Subject: FUEL DENSIFICATION

APPENDIX I TO AEC ORDER

CHANGE NO. 12 TO THE TECHNICAL SPECIFICATIONS

SAFETY EVALUATION OF THE  
FUEL DENSIFICATION EFFECTS ON THE  
DRESDEN NUCLEAR POWER STATION UNIT 3

FIGURE 3.5.1 MAXIMUM ALLOWABLE PLANAR LHGR

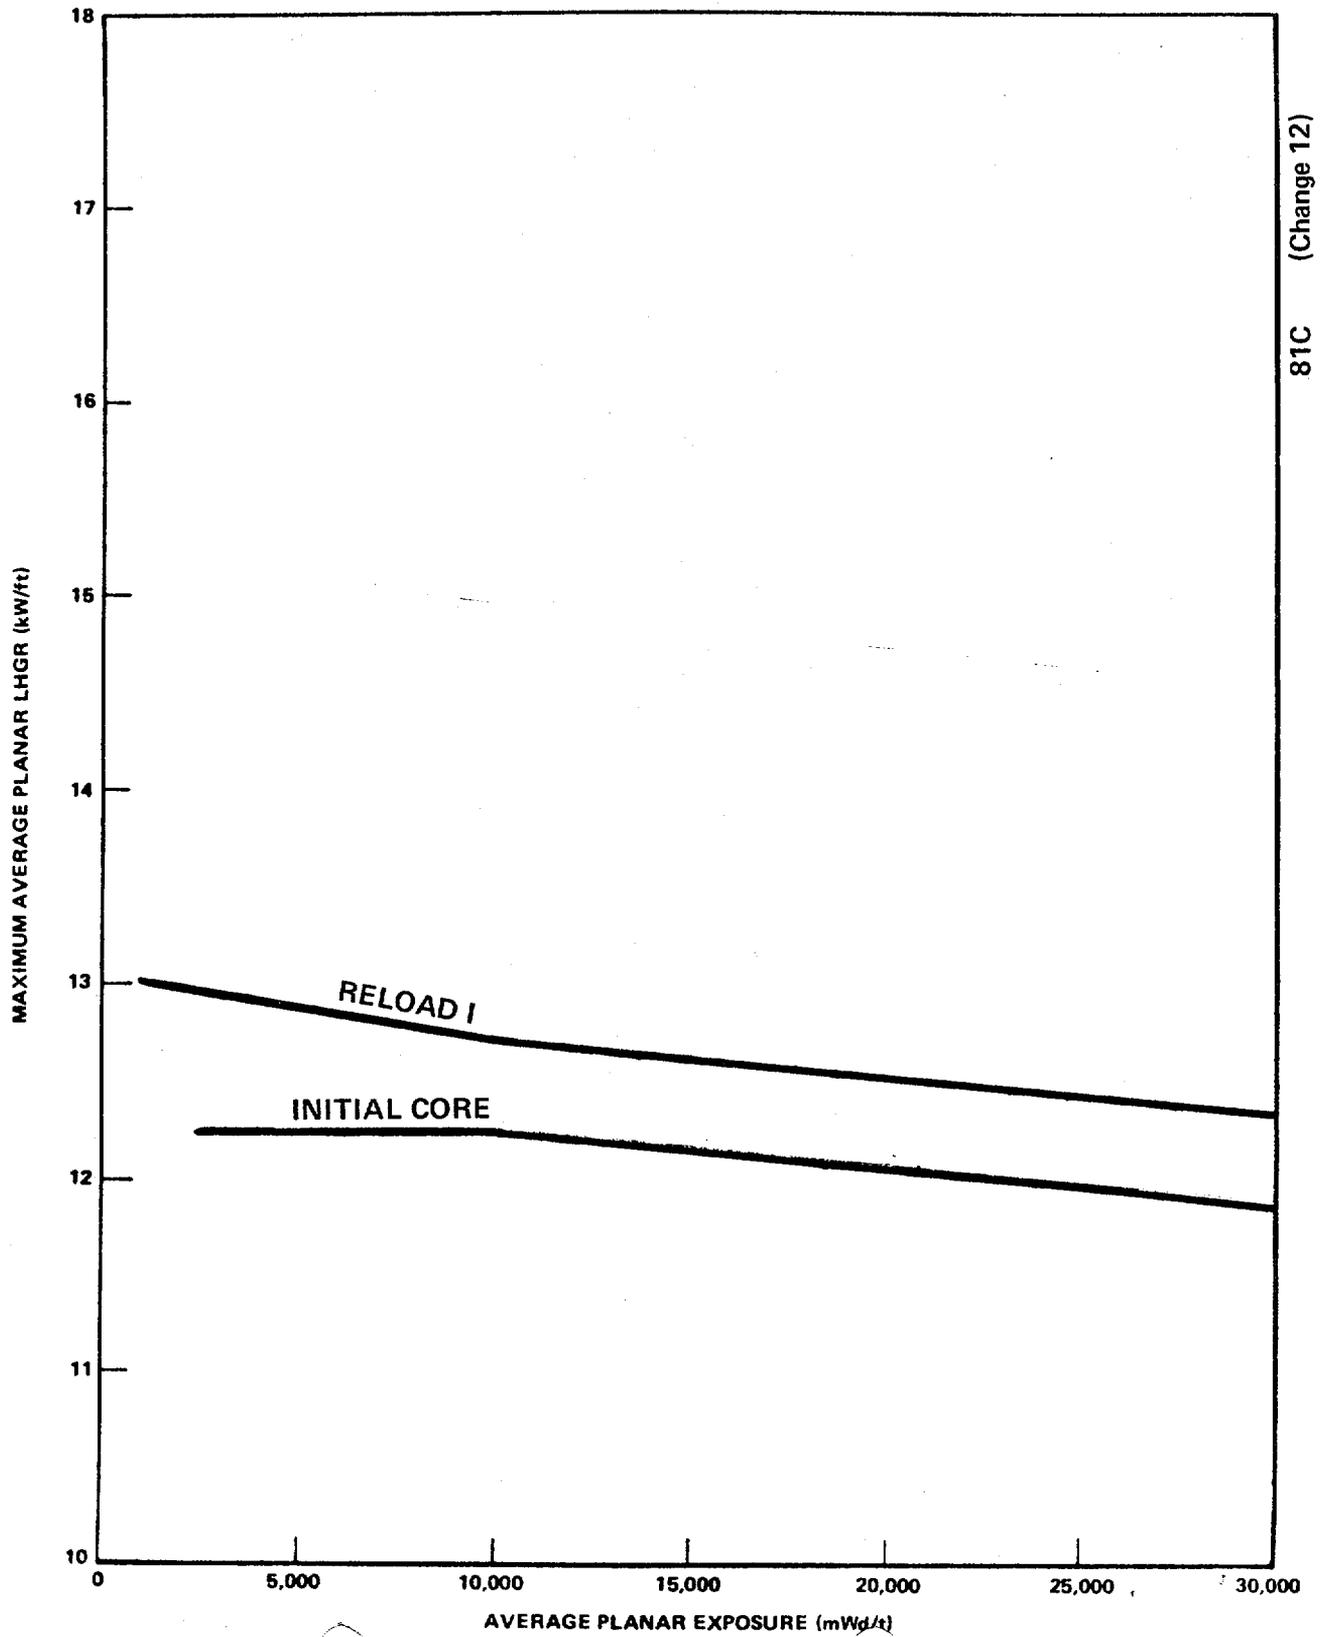
During steady state power operation, the average linear heat generation rate (LHGR) of all the rods in any fuel assembly, as a function of average planar exposure, at any axial location, shall not exceed the maximum average planar LHGR shown in Figure 3.5.1.

The maximum average planar LHGR shown in Figure 3.5.1 is the same as that shown on the curve labeled " $\gamma$ " (gamma) on Figures 4-9J1 and 4-9J2 of the GE topical report "Fuel Densification Effects on General Electric Boiling Water Reactor Fuel," NEDM-10735, Supplement 6, August 1973 and is the result of the calculations presented in Section 4.3.4 of the same report. These calculations were made to determine the effect of densification on peak clad temperature and were performed in accordance with the AEC Fuel Densification Model for BWR's which is attached to NEDM-10735, Supplement 6 as Appendix B.
